UNITED STATES PATENT AND TRADEMARK OFFICE

Office Action Summary

10/614,729

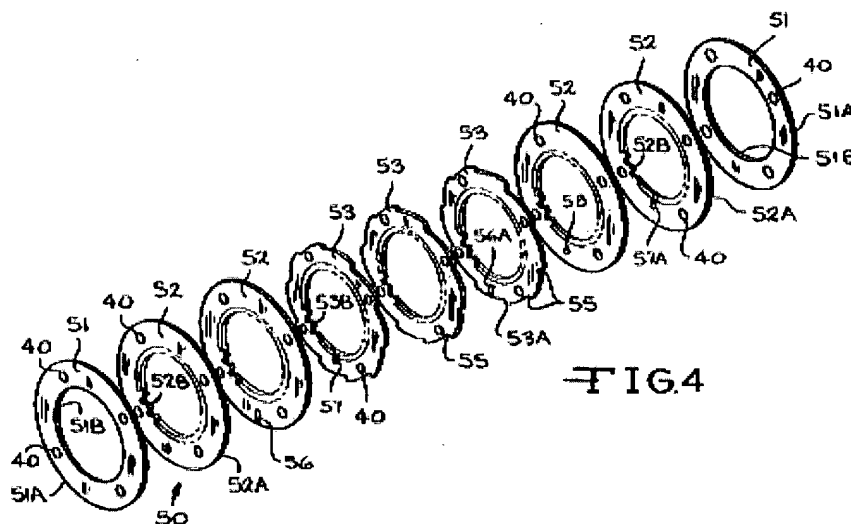
Claims 1-6 and 8, as understood, are rejected under 35 U.S.C. 102(b) as being anticipated by Quigley ('279).

Quigley discloses a no-back device (Fig. 1) comprising a plurality of ratchet members (22) connectable to a rotating member, pawls (25), interlocking means (40), projections and indentations (Fig. 3, 40, 41). Regarding the limitation that the "ratchets/pawls members are formed from respective materials having different chemical and/or physical properties", the prior art discloses discrete members that would inherently exhibit distinct properties (point, linear, planar, and three-dimensional defects; in additions to those unique qualities caused by processing – e.g., voids, etc.) that yielding different physical traits. Concerning claim 1, since no frame of reference has been given for the angular offset of the ratchet member (e.g., teeth), any two arbitrary points would satisfy the claimed limitation.
